Dear Members of the Technical Advisory Committee,

**Proposed
Satellite
Parking Lot**

Portsmouth Regional
Hospital

SITE SPECIFIC SOIL PLAN

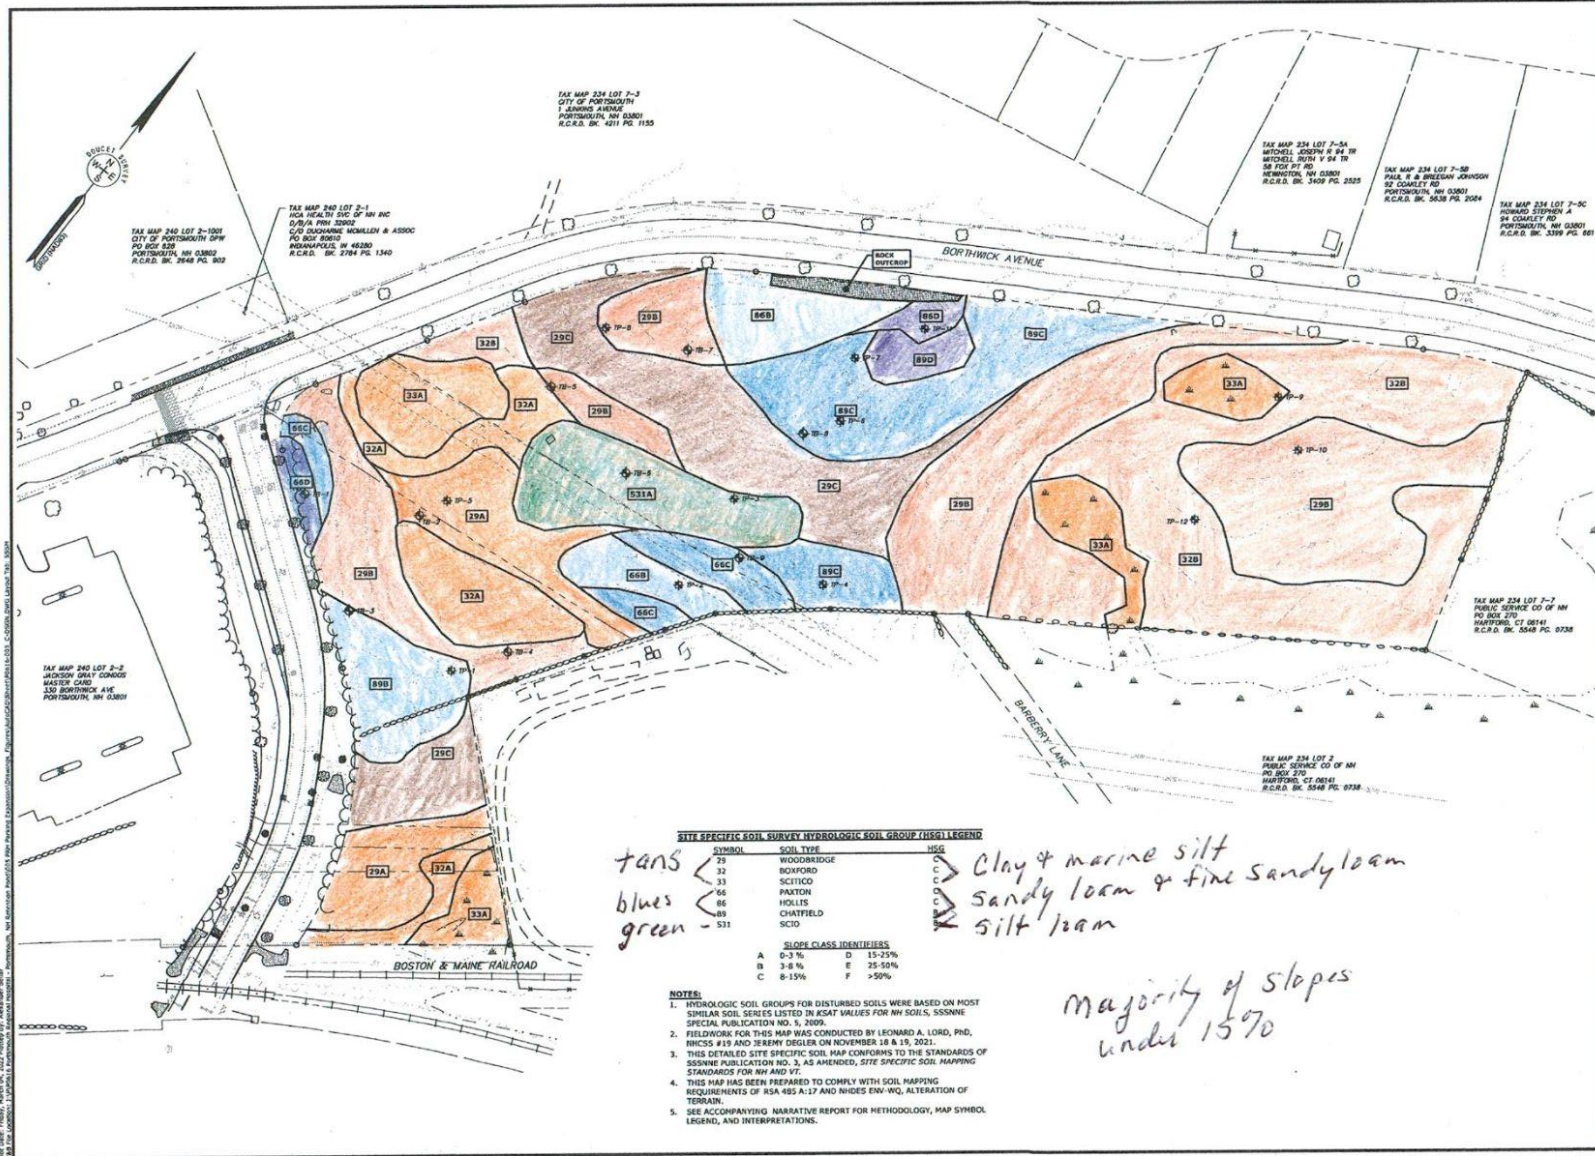
Looking at the "Site Specific Soil Plan" (colored graphic at end) the majority of the soil on this property is clay and marine silt (tans) It shows silt loam(green) in the middle of the proposed parking lot. The land is relatively flat with most slopes in the 0-8% range and the majority under 15%. Section 3 (3.1 drainage analysis) states the detention system will drain down at longer than 24 hours. However, looking at the majority of soil on this land (clay, marine silt) under existing conditions, drainage based on CECs could take a long time to clear a single rainfall event. ***The capacity of the underground retention systems is the concern.*** It does not seem to decrease existing drainage but seems to increase drainage into the wetlands at a far greater rate than currently exist. The "post" curve number average is 79.4 (range 30-100), some of post CN are in the 90s comparing the 2 year pre and post conditions (included at end). Flows greater than the 2 year storm events will bypass the treatment units. Based on normal New England weather it seems a lot of the water will go untreated into the wetland at a much higher rate than existing which was filtered through trees, brushes, grasses and slowly absorbed by clay and marine silt. ***Does this meet MS4 regulations?***
